BCA Design Assessment Report

Kyeemagh Public School - Core 14
Jacobson Avenue
Kyeemagh NSW 2216

Project: Kyeemagh Public School – Core 14
 Document Type: Access Design Assessment Report
 Report Number: P219_322-2 (ACCESS) NH

Figure 1 – Site plan

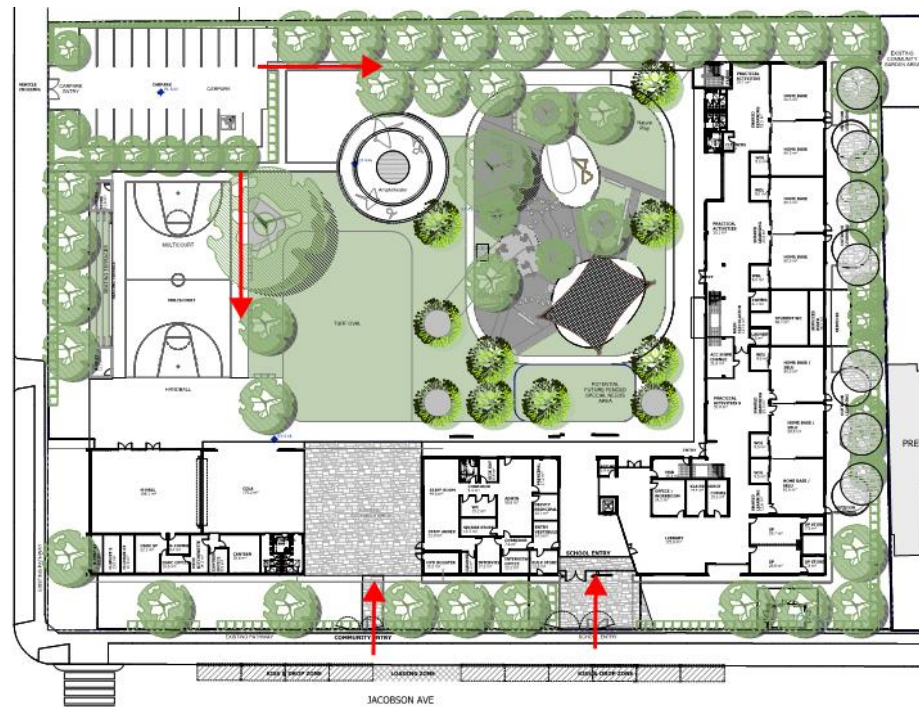
- (i) The following rooms / areas and associated accessways have been afforded the concession under D3.4 and access for people with disabilities need not be provided to these areas—
 - Storage room/s;
 - Plant and equipment room/s.
- (ii) The seating area adjacent to the Games Court has been treated as having fixed seating;
- (iii) An accessway has been assessed as being provided each side of the Games Court from the proposed carpark to the building/s, as indicated in figure 1 below;

- (iv) The pedestrian entrances to the school have been assessed as being located as per figure 1 below.

Figure 02 – Offset tread within stairs

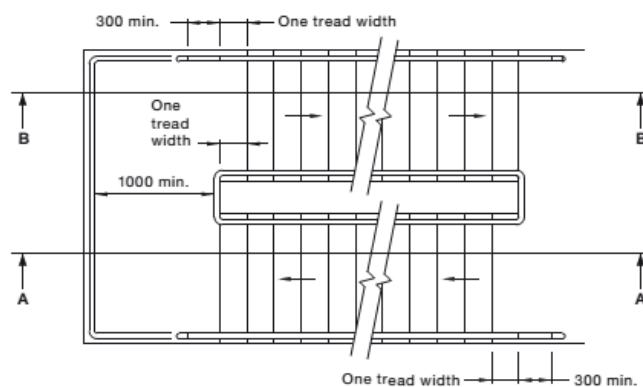
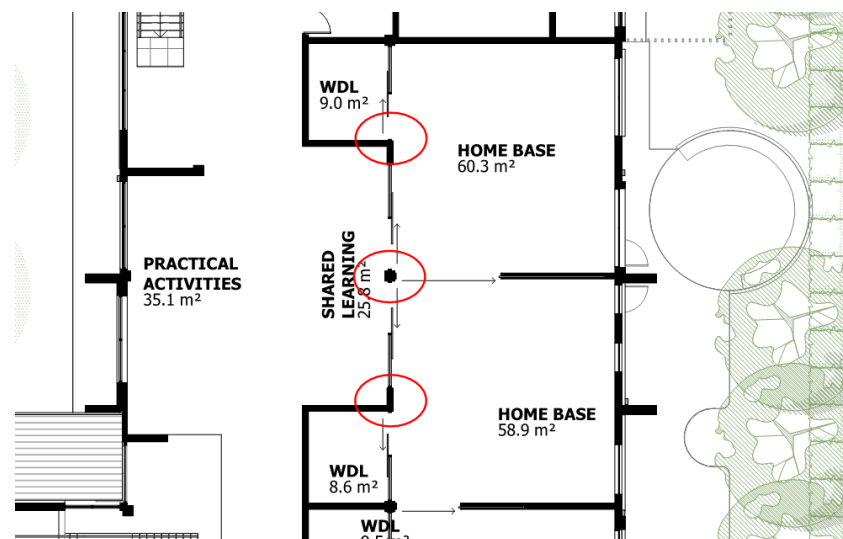
- have a sharp intersection; or
 - be rounded up to 5 mm radius.
- (v) At the nosing, each tread shall have a strip not less than 50 mm and not more than 75mm deep across the full width of the path of travel with 30% luminance contrast to the background;
- (vi) The contrast strip may be set back a maximum of 15mm from the front of the nosing; and
- (vii) Stairways, other than fire-isolated stairways, must comply with clause 11 and 12 of AS1428.1-2009.

- (i) Stair located within internal corridors to be recessed one (1) tread-width and handrail extension with downturn to avoid protrusion into transverse path of travel
- (ii) Any riser contained within a stairway must be opaque;
- (iii) Riser to have a maximum vertical splay of 25mm from the nosing;
- (iv) Stair nosing profiles shall:
 - (i) be chamfered up to 5 mm × 5 mm; or
 - (ii) have a sharp intersection; or
 - (iii) be rounded up to 5 mm radius.
- (v) At the nosing, each tread shall have a strip not less than 50 mm and not more than 75mm deep across the full width of the path of travel with 30% luminance contrast to the background;
- (vi) The contrast strip may be set back a maximum of 15mm from the front of the nosing;
- (vii) Stairways must comply with Clause 11 and 12 of AS1428.1-2009. This may require an offset tread (see Figure 09 above).
